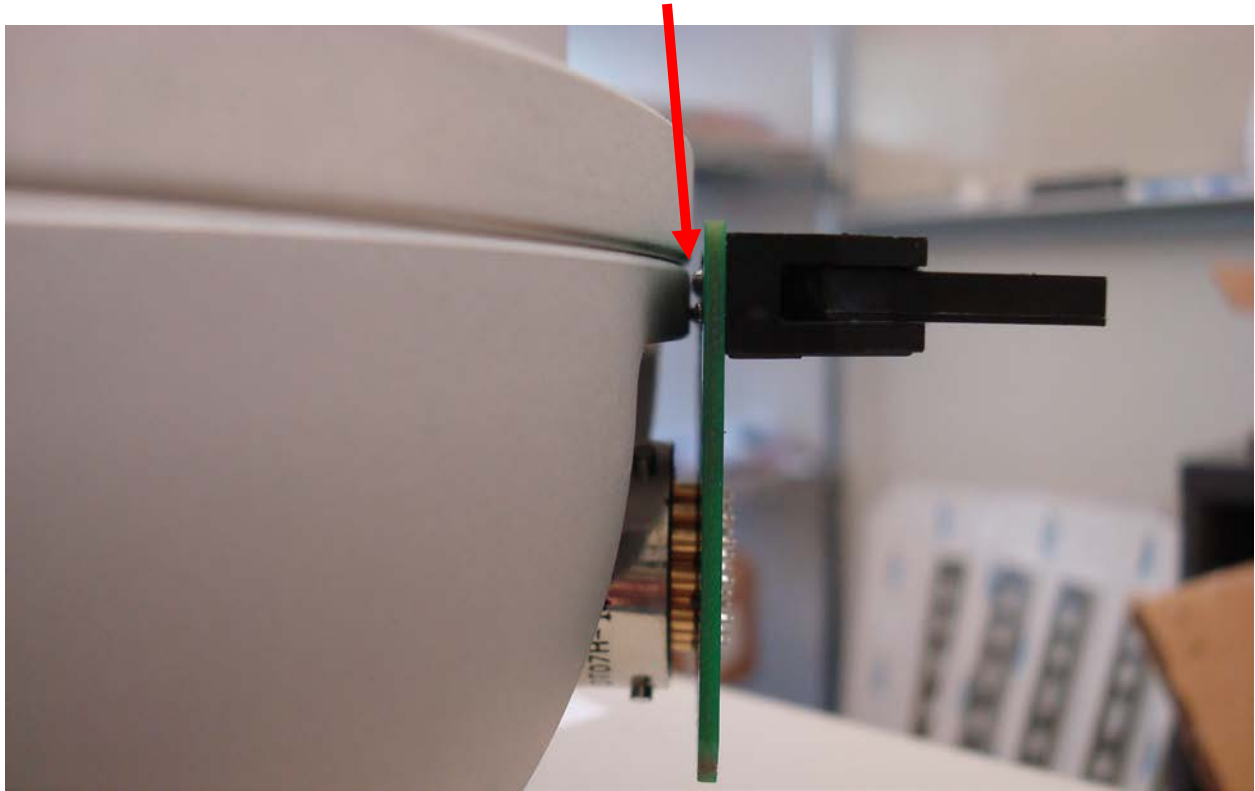
The old connector from the side. It can be seen that, although we have trimmed the pins of the IDC connector, they still touch the enclosure, and would short out.

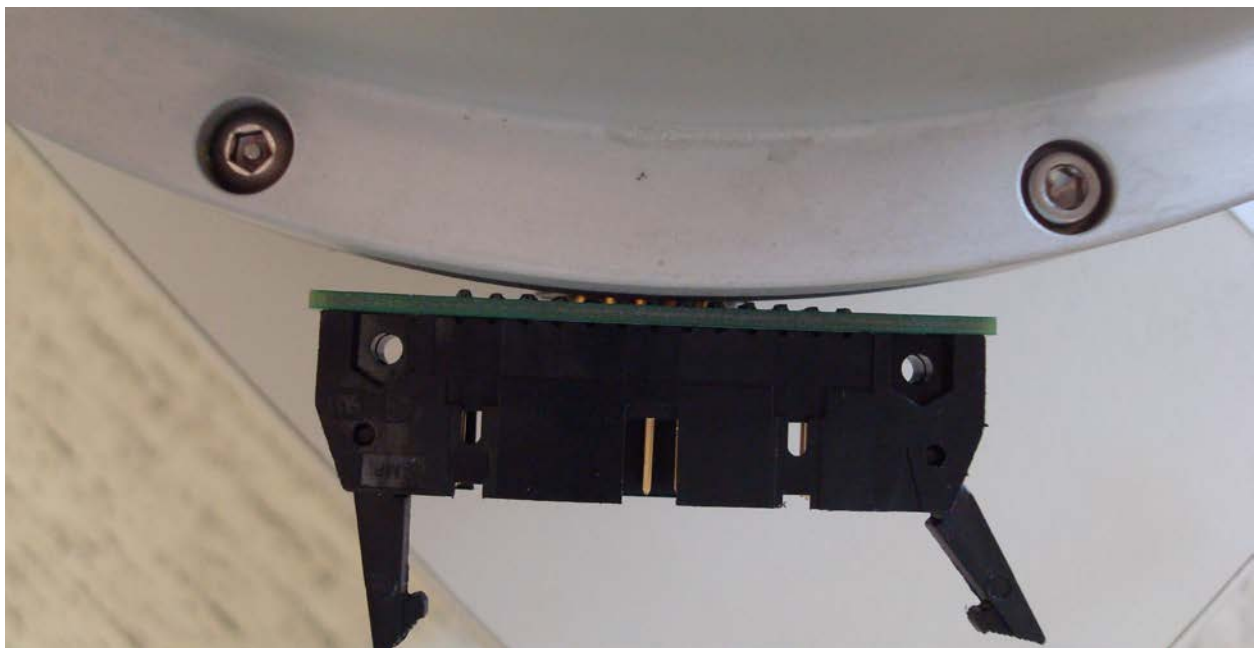
This is a top view of the same connector board, showing the pins contacting the enclosure.

Here is a picture of the old board (Left), and the new board (Right). The new board uses a SMT Header , so there are no pins to short out. The new board is 1/4" taller than the old one, I hope it doesn't interfere with the fit. The extra height made room for the surface traces for the SMT header.

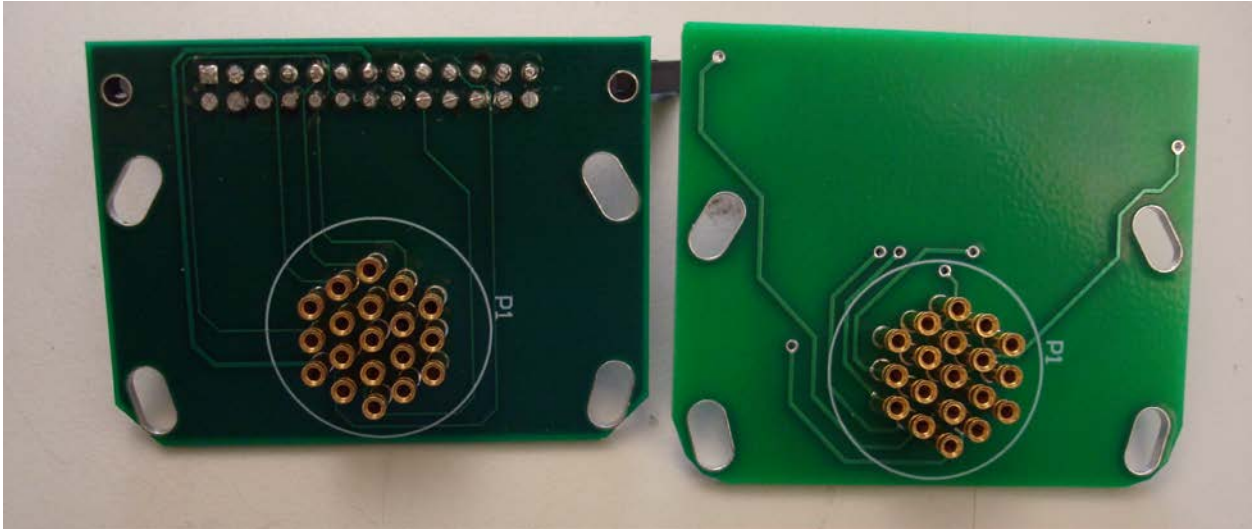
The new board installed: The screws are on order, which is why they're not installed yet. The holes seem to line up well.
